# Product Change Notification

## 113824- 00

**Change Notification #:** 113824 - 00  
**Change Title:** Intel® Server Chassis P4208XXMHGC  
PCN 113824-00, Product Design, Label  
Update 750W Common Redundant Power  
Supply FXX750PCRPS Firmware, Update  
the Safety & Regulatory labels, Update the  
Front Panel Printed Circuit Board and Power  
Button LED and Change Capacitor and  
Cable  
**Date of Publication:** April 28, 2015

Figure-1: Pre-Change

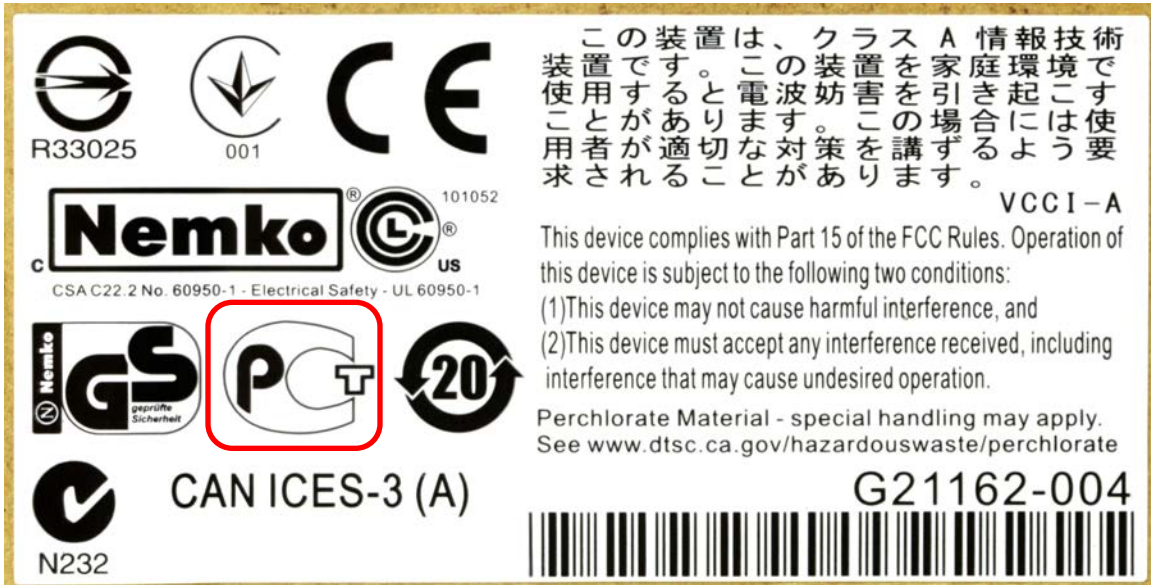
2. Update the Safety Label: Put an EAC logo instead of a GOST logo for certification update. Please see Figure-1 and Figure-2 below for details.

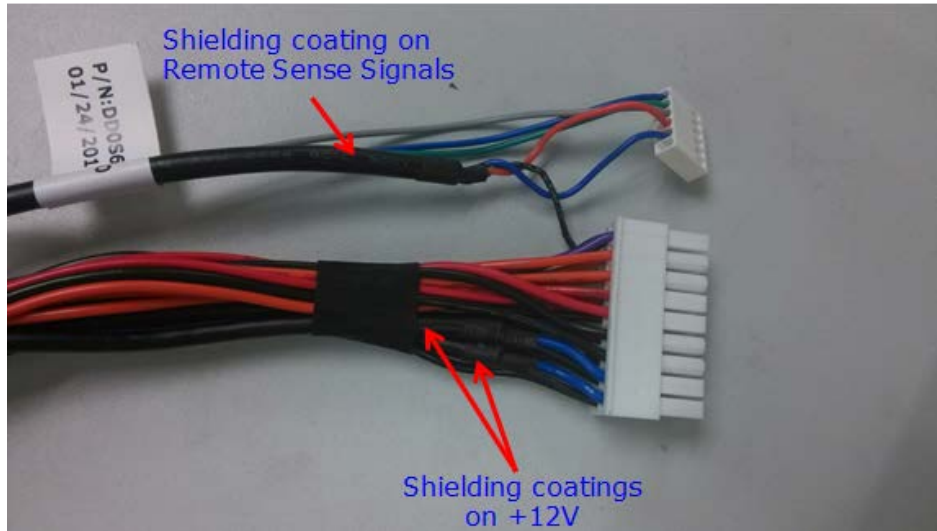
- Increase the capacitor values of C11 and C13 from 0.1 $\mu$ F to 2.2 $\mu$ F to extend the duration of the Over Current Protection circuit from 0.6ms to 8.0ms. Please refer to the TA-1056-01 for more details.
